**UNITED STATES
NUCLEAR REGULATORY COMMISSION**
WASHINGTON, D.C. 20555-0001

**SUBJECT: DAVIS-BESSE NUCLEAR POWER STATION, UNIT 1 - STAFF ASSESSMENT
 OF FLOODING FOCUSED EVALUATION (EPID NO. L-2019-JLD-0007)**

STAFF ASSESSMENT BY THE OFFICE OF NUCLEAR REACTOR REGULATION
RELATED TO THE FOCUSED EVALUATION FOR
DAVIS-BESSE NUCLEAR POWER STATION, UNIT 1
AS A RESULT OF THE REEVALUATED FLOODING HAZARD NEAR-TERM TASK FORCE
RECOMMENDATION 2.1 - FLOODING
EPID NO. L-2019-JLD-0007

Figure 3.2-1 Davis-Besse Site Layout (taken from licensee's February 25, 2015, FHRR)

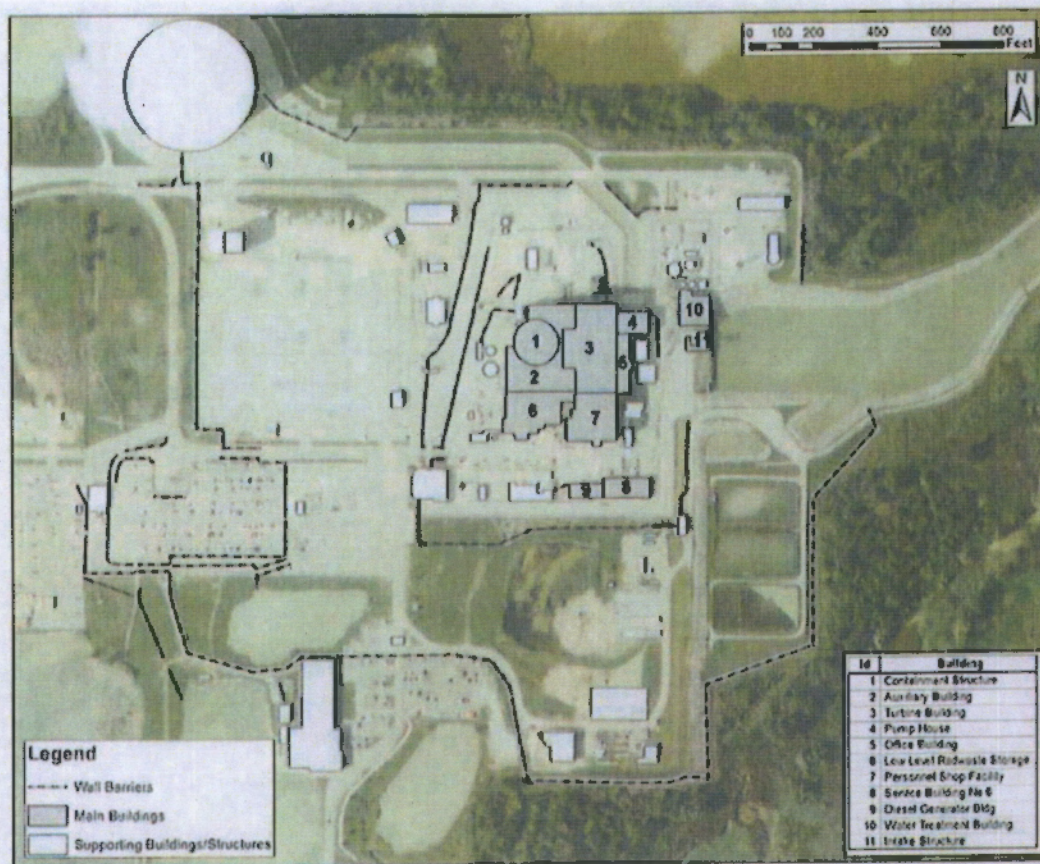
The ISR LIP evaluation generated a maximum ponding level of 585.5 ft, which exceeds the safety-related building entry point levels of 585 ft. Based on this potential for in-leakage, the staff reviewed the key SSCs in each potentially affected building. Figure 3.2-1 provides a site layout. The staff also considered the February 25, 2015, FHRR and ISR LIP flood elevations at key doors that are summarized in Table 3.2-1.

As shown in Table 3.2-1 the total inundation period in the power block area is approximately 30 minutes with the exception of door 224, which is approximately 48 minutes and door 334 which is approximately 75 minutes. As discussed above, should water enter the turbine building, water would be prevented from entering safety-related areas by curbing in the turbine building and auxiliary building, and the available free volume in turbine building to hold water. The staff concludes that the key SSCs and their associated KSFs are effectively protected against the ISR LIP flood levels because:

- Exterior doors would minimize water intrusion into safety-related areas of the plant.
- In some cases, plant curbing would direct water away from entering safety-related portions of the plant. For example, water entering into the plant through the turbine building would be directed away from safety-related portions of the plant by both turbine building curbing and curbing inside the auxiliary building. In cases where curbing does

Therefore, the staff concludes that the licensee meets the guidance in NEI 16-05, Revision 1, as endorsed by the NRC, of a Path 2 evaluation (i.e., "effective flood protection") for the ISR LIP flood mechanism such that KSFs (without reliance on FLEX) can reasonably be expected to be met with installed plant equipment.
